STATE OF NORTH CAROLINA  
DEPARTMENT OF TRANSPORTATION

Subject: *Updated information for the Application Requesting Modification of Section 404 Individual Permit and Section 401 Water Quality Certification for the U-2579B Section of the Winston-Salem Northern Beltway, from US 158 to I-40 Business/US 421, Forsyth County, Division 9, WBS 34839.2.10*

*This letter and permit drawings dated January 14, 2020, are an update (shown in italics) to the previous letter and permit drawings submitted with the October 21, 2019 application for the Smith Creek relocation permit modification.*

**PERMIT DRAWING  
MODIFICATION FOR  
SITE 23 AND 28**

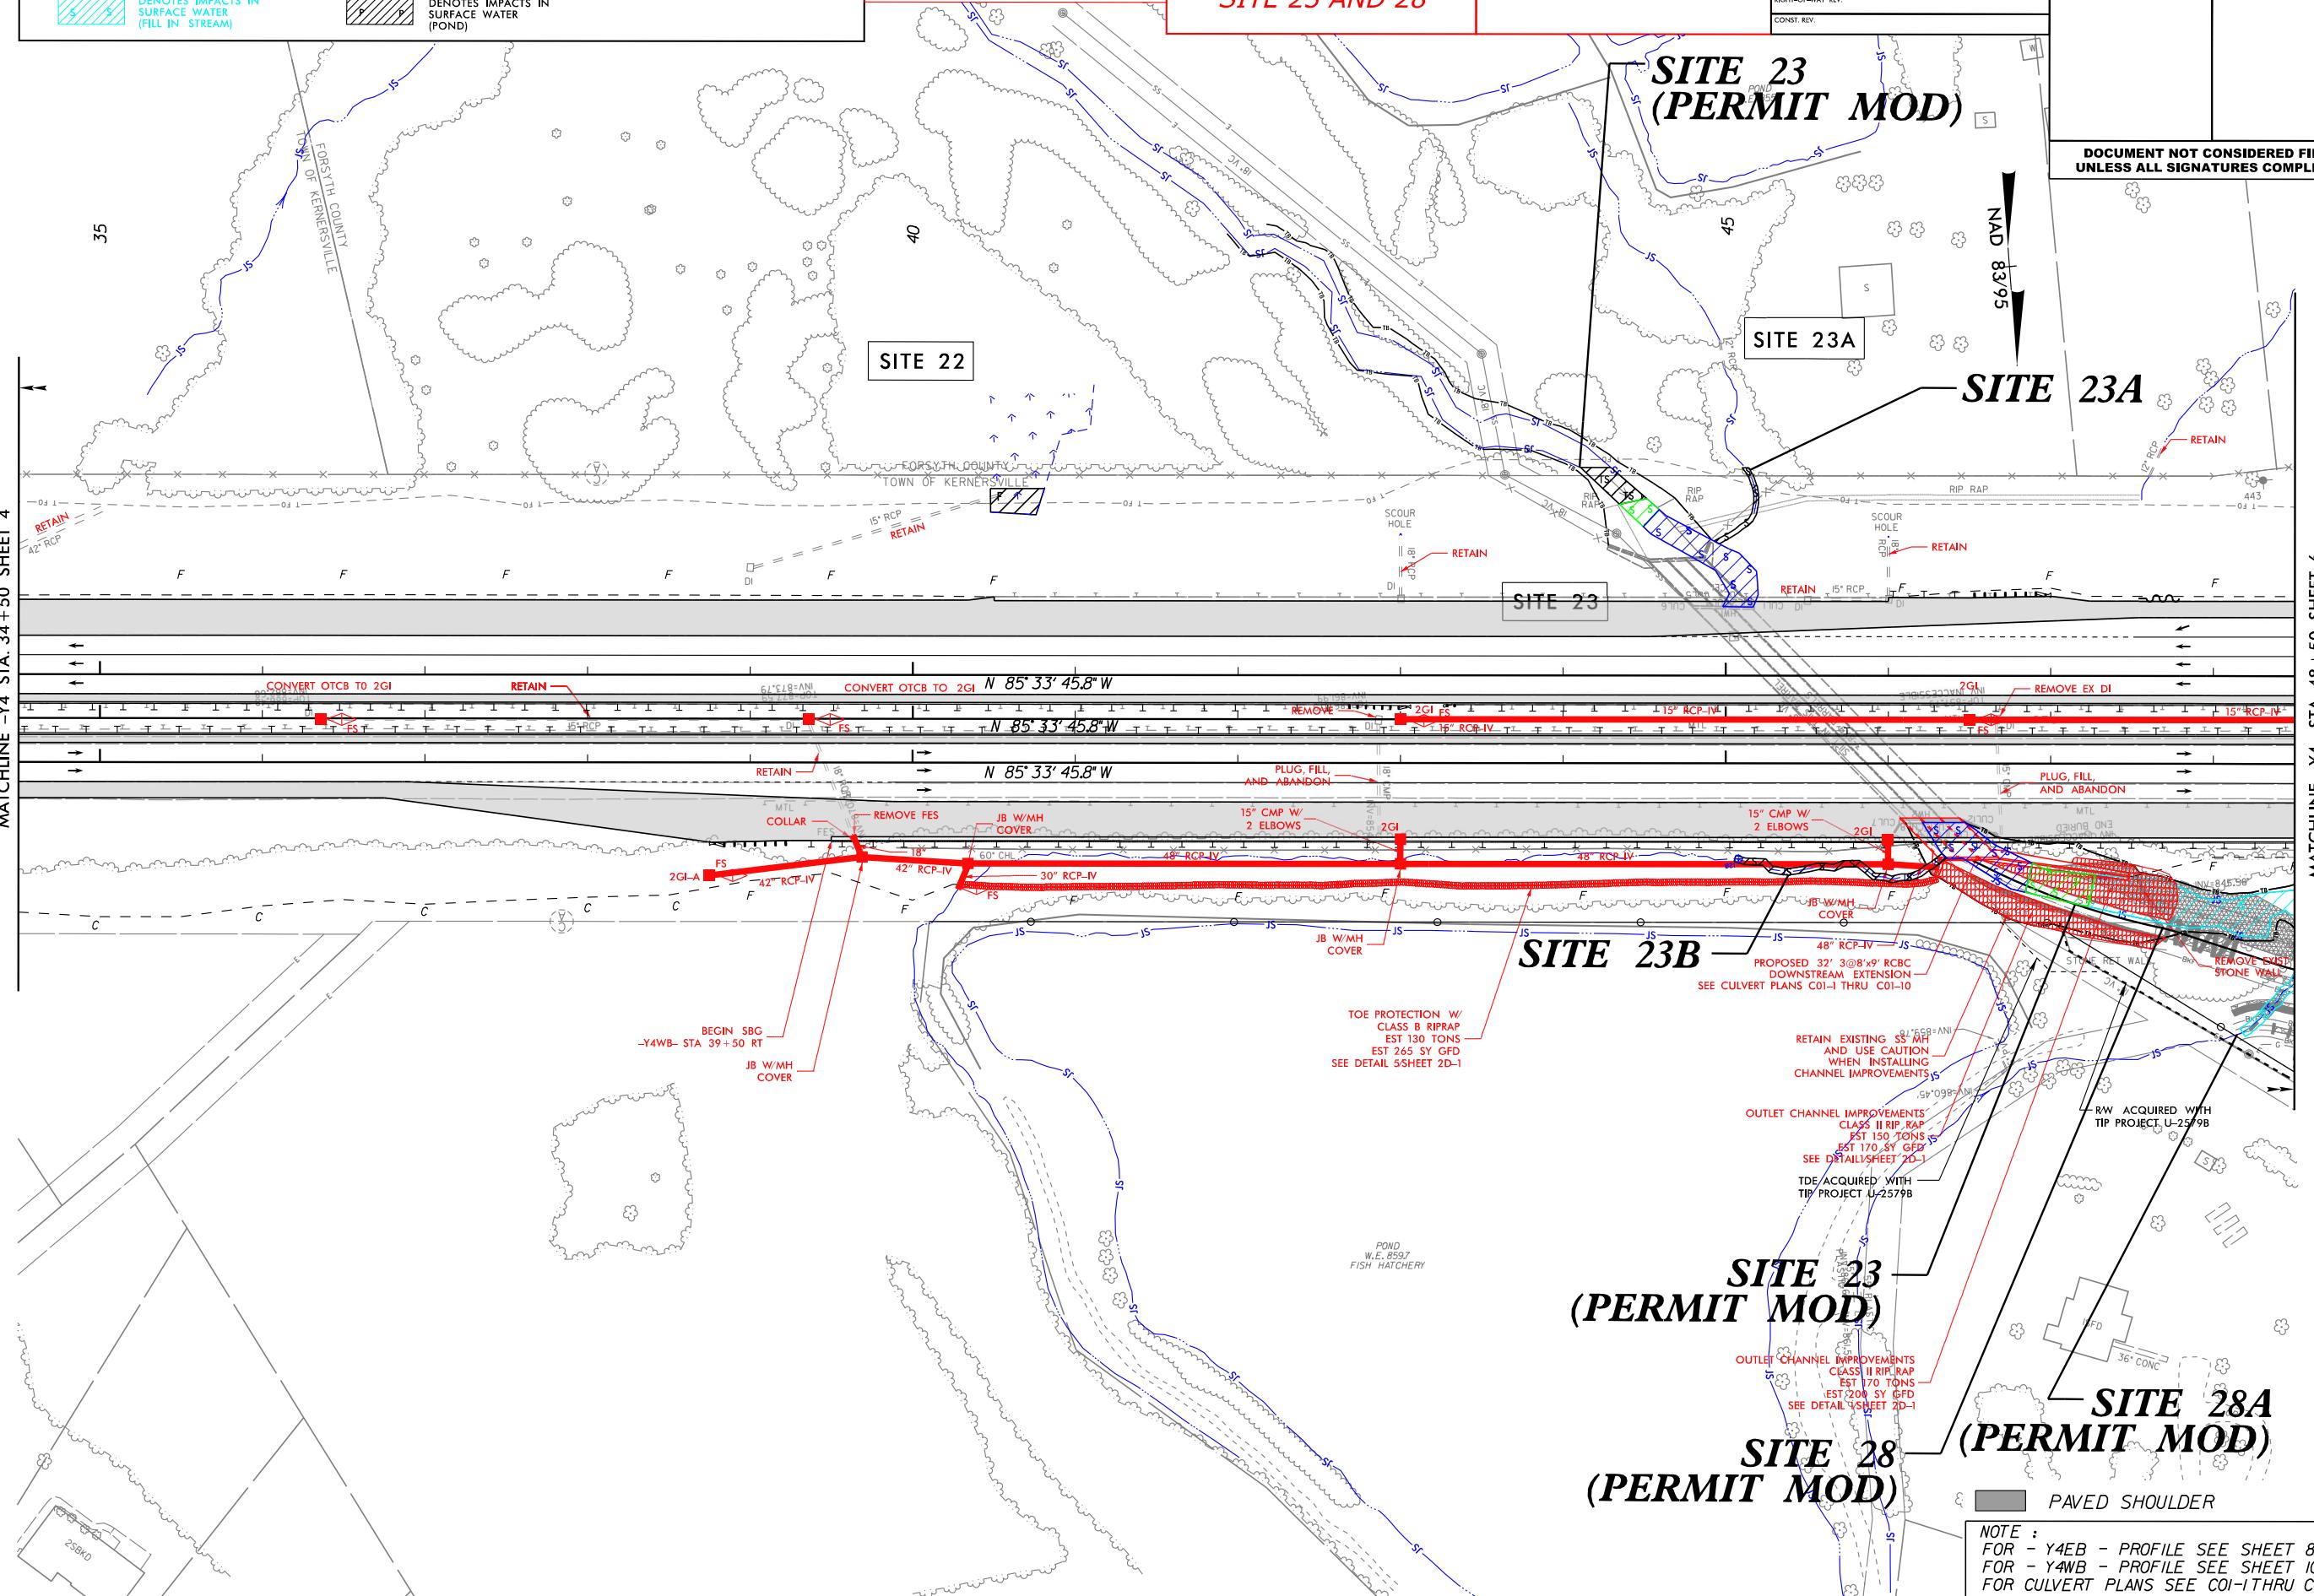
*This update is required due to two minor design revisions. The landowner adjacent to the proposed relocation of Smith Creek owns several fish ponds and has utilized the Creek to fill the ponds each year. To enable the land owner the use of the Creek to fill his ponds, it is necessary to install a stream intake vault (see Permit Drawing Sheet 2 of 18) at the north end of the relocated stream (see Permit Drawing Sheet 14 of 18). This change will involve 12 linear feet of bank stabilization impacts as part of this modification at Site 28.*

Site 23            +19 Linear Feet

Site 28            -62 Linear Feet

JANUARY 14, 2020  
PERMIT DRAWING  
SHEET 12 OF 18PERMIT DRAWING  
MODIFICATION FOR  
SITE 28PREVIOUS U-2579B  
SHEET 26/27Kimley Horn  
©2019  
421 FAYETTEVILLE STREET, SUITE 600  
RALEIGH, NC 27601

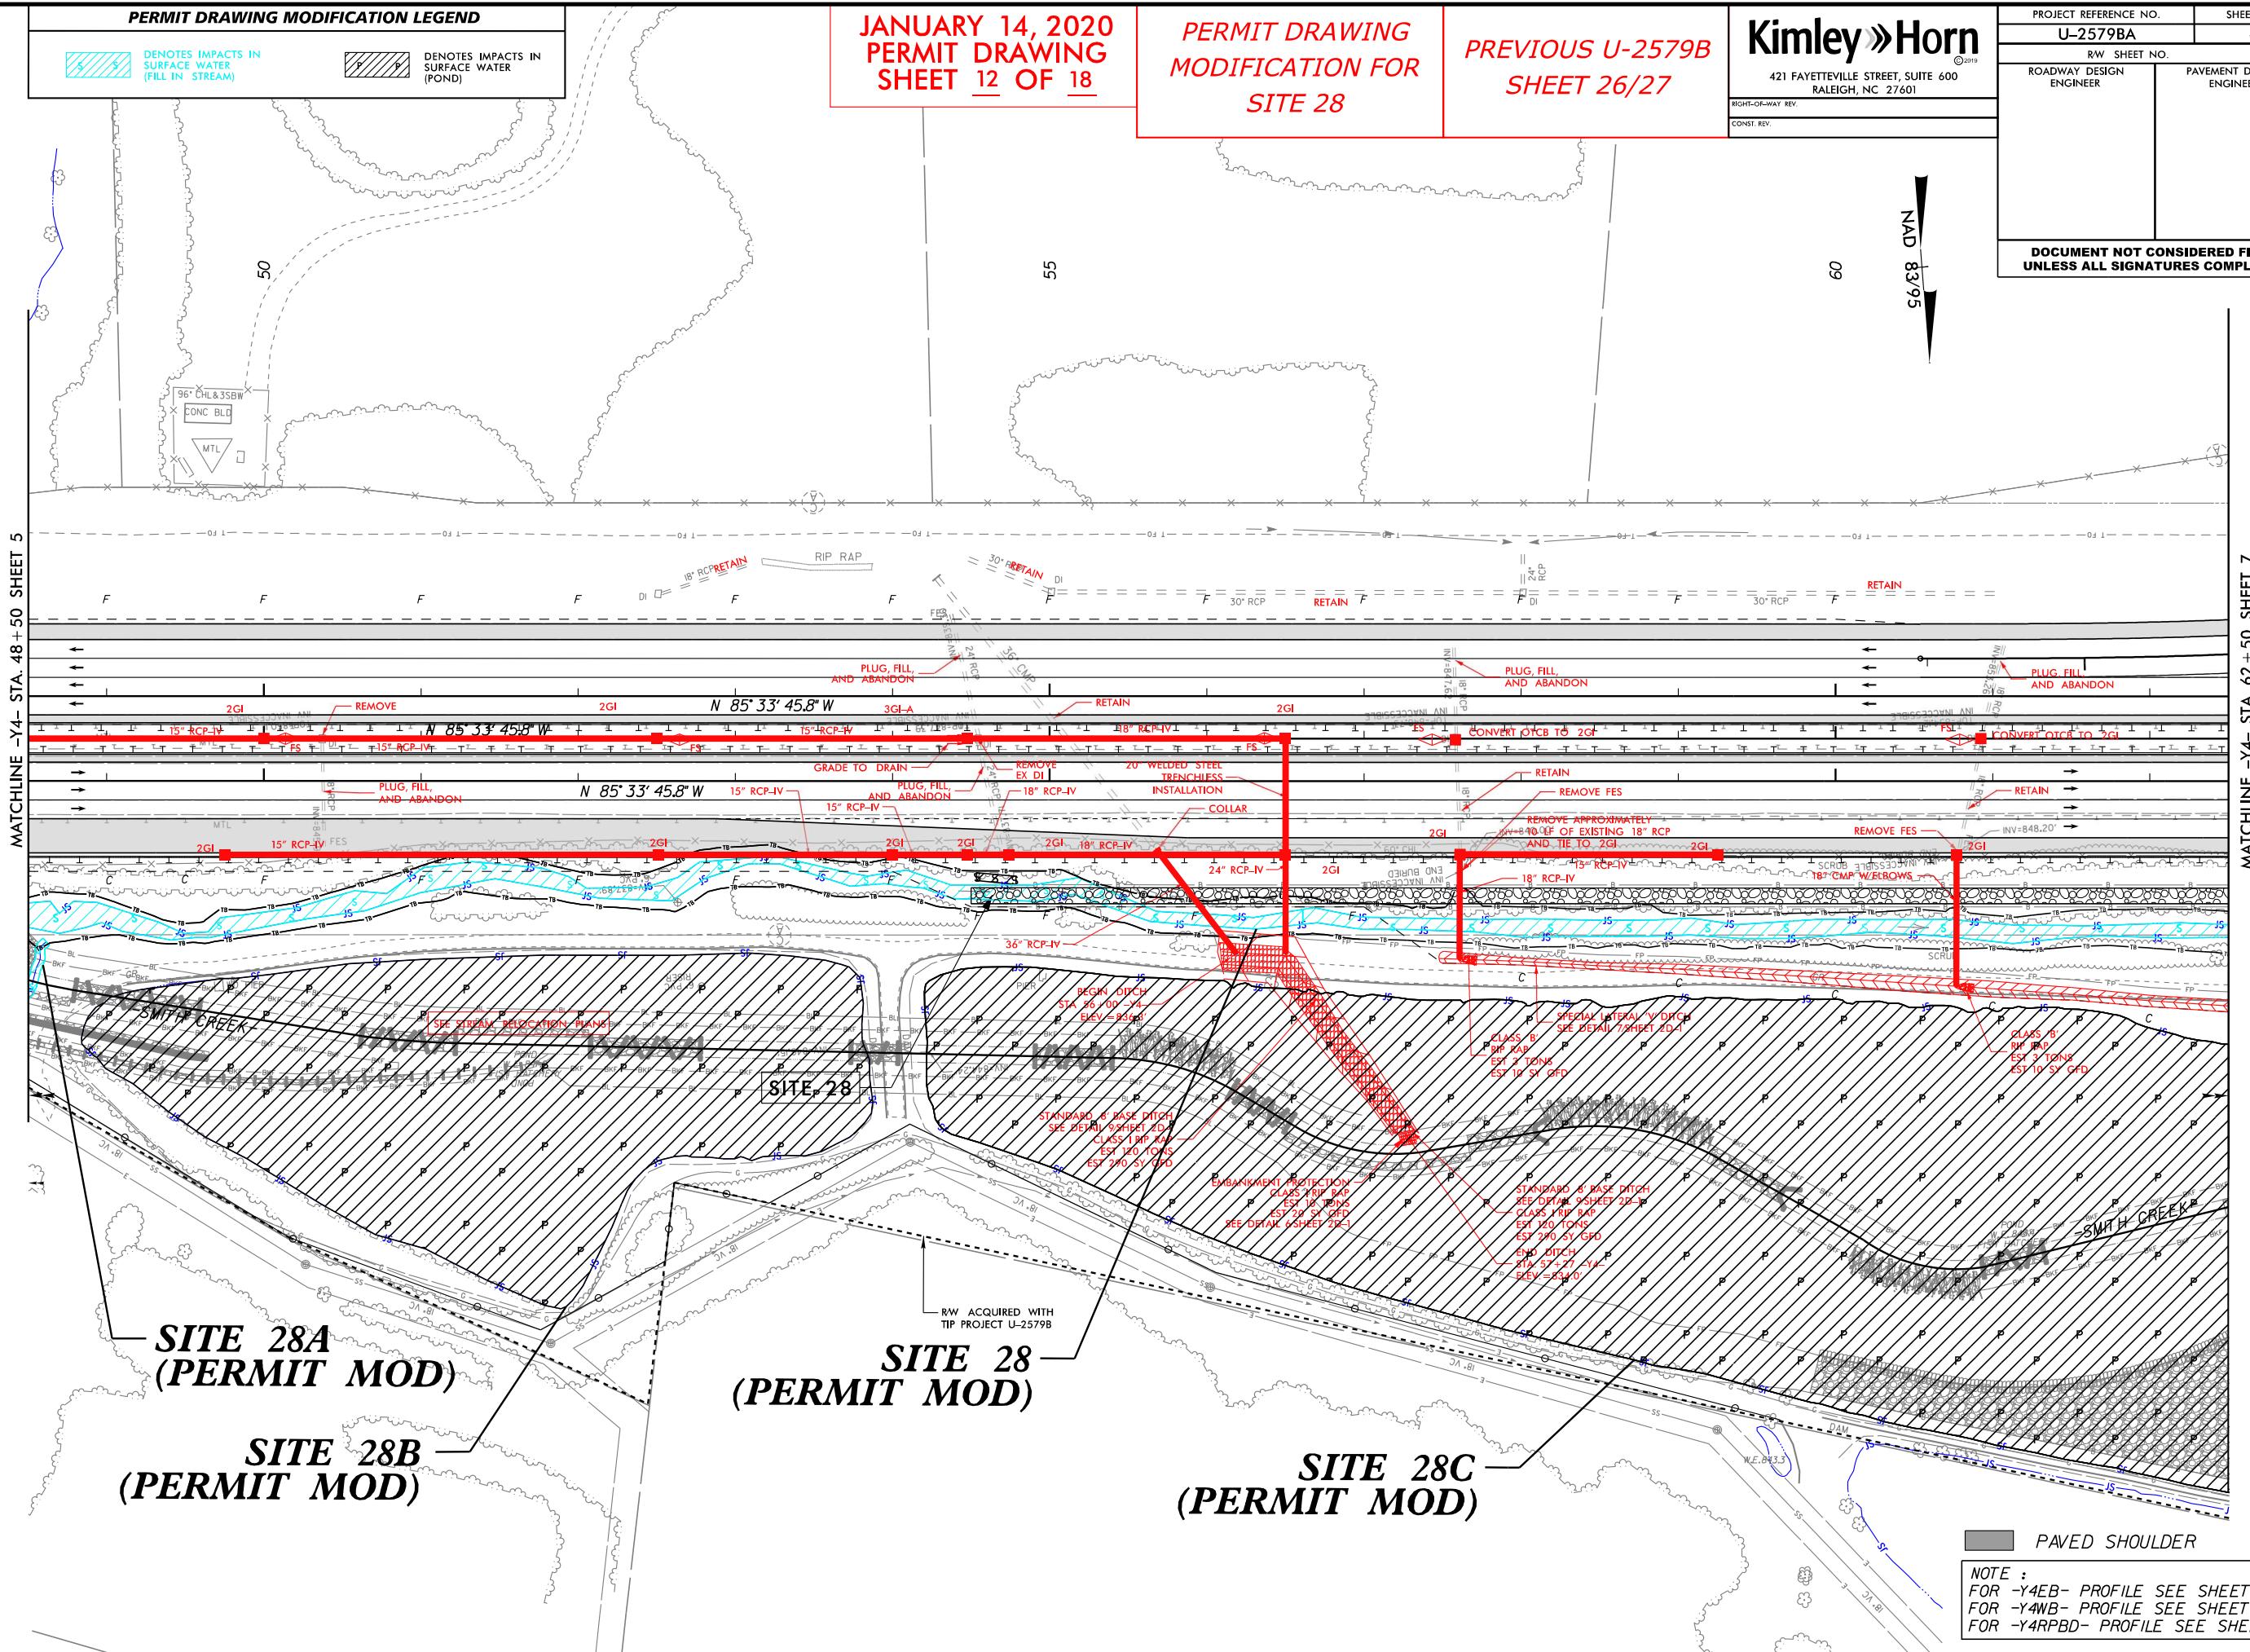
Additionally, Site 28A will have an increase of Natural Stream Design (NSD) due to a better alignment for the confluence of UT Smith Creek to the mainstem. This will increase the NSD at site 28A from 344 linear feet to 384 linear feet.

There will be new impacts to ponds for this modification. Pond 1 and Pond 2 will be drained to accommodate the relocation of Smith Creek totaling 7.82 acre of impacts.
